RE: Response to Initial Peer Review  
Special Permit, Variance, and Site Plan Review Application  
3127 Cranberry Highway  
Wareham, MA  
ZBA Case 11-23  
**G.A.F. Job No. 22-9890**

G.A.F. Engineering, Inc., on behalf of our client Peter Koulouras, provides the following responses to the review comments received from Allen & Major Associates, Inc by letter dated August 23, 2023. Revised plans dated August 30, 2023 is included with the submittal.

## COMMERCIAL STEEL LANDSCAPE EDGING

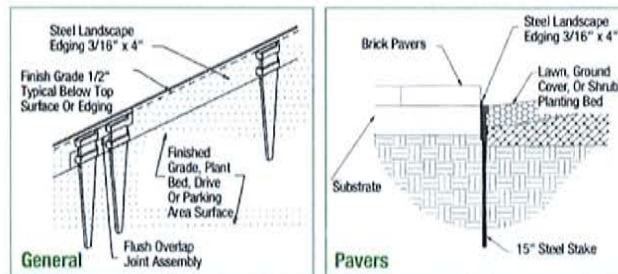
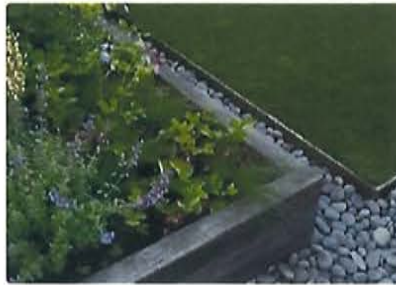
10. The design engineer should provide a detail on the proposed steel landscape edging. The 4" reveal above existing grade will further trap existing stormwater runoff along the easterly and westerly property line. The design engineer should also review the impact that may occur to the steel edging during snow plowing activities on the two adjacent properties.

***The steel edging is ¼ inch thick steel specifically used for commercial use (see attached cut sheet). Although the adjacent properties are surfaced with a bituminous concrete surface no parking stalls or travel isles are***

**located near the proposed edging. The edging is robust enough to serve as a guiding edge for snow plowing. The detail of the steel edging is shown on sheet 9 of 10 (ground cover and shrub planting detail) and noted on the Landscape Plan sheet 7 of 10.**

# First Defense® High Capacity

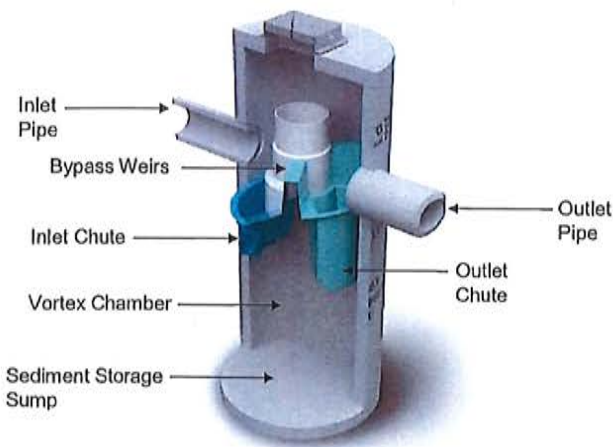
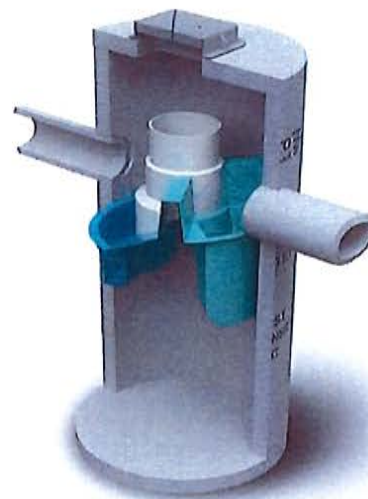
15. The design engineer has accounted for 80% TSS removal rate for a proprietary treatment device (First Defense FDHC-3 Unit). No calculations or third-party testing data has been provided to demonstrate this removal rate. Proprietary treatment devices are typically maxed out at 50% unless documentation is provided. The design engineer should update the TSS worksheets accordingly.

***The water quality volume to discharge rate calculation previously provided indicates a flow rate of 0.29 cfs for a one-inch water quality volume over the proposed impervious surfaces. The FDHC-3 unit is rated for 80% TSS removal at 1.06 cfs which is more than 3 times the required rate. Refer to the attached data from Hydro International.***
